**Lima Energy Company Project
Application for Amendment Number 2
In OPSB Case Number 00-513-EL-BGN
First Amendment Case Number 04-1011-BGA
Second Amendment Case Number 14-1142-EL-BGA**

Lima Energy Company
Ultra Clean Synthetic Crude Production Project
Application for Amendment Number 2
To The OPSB Certificate
In OPSB Case Number 00-513-EL-BGN
And First Amendment Case Number 04-1011-BGA

Case Number 14-1142-EL-BGA

**Lima Energy Company
Ultra Clean Synthetic Crude Project
Application for Amendment Number 2
To The OPSB Certificate
In OPSB Case Number 00-513-EL-BGN
And First Amendment Case Number 04-1011-BGA
Second Amendment Case Number 14-1142-EL-BGA**

**Lima Energy Company
Ultra Clean Synthetic Crude Production Facility
Simplified Block Flow Diagram**

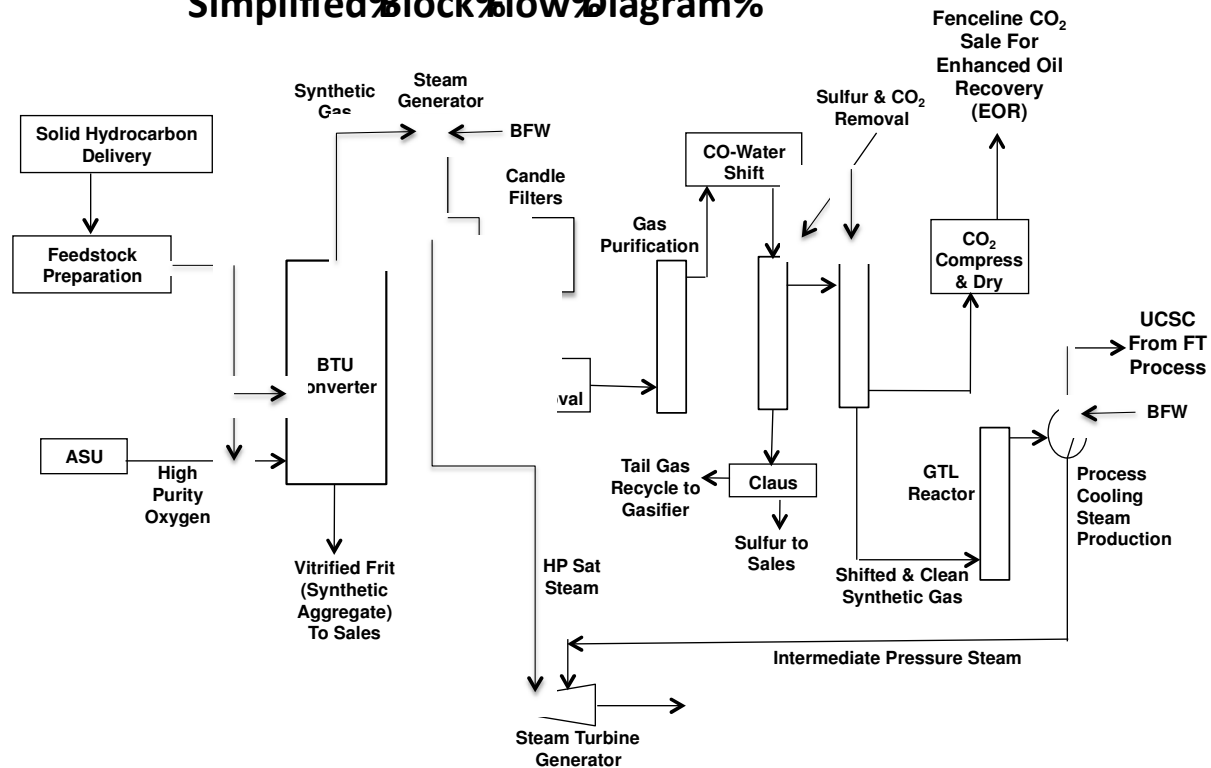
The gasification technology and reconfiguration of the facility to produce UCSC does not materially change:

- (A) Site Technical Data; or
- (B) Layout Technical Data
- (C) Equipment Technical Data is modified as follows:
 - (C)(1) Material Handling

As previously noted, the gasifiers will be an entrained flow technology, rather than a fixed bed technology. In these, the pulverized feed is conveyed into the gasifier under pressure. The chemical conversion of solid feed materials to synthetic gas is similar in all slagging gasifier technologies and the resulting synthesis gas will be similar in composition to that described in the origin application.

As noted earlier, each ASU will produce high-purity oxygen for the gasification process. Nitrogen will also be produced, and used primarily for various process system operations and inerting certain process units, and purging units during shutdowns to enable safe maintenance.
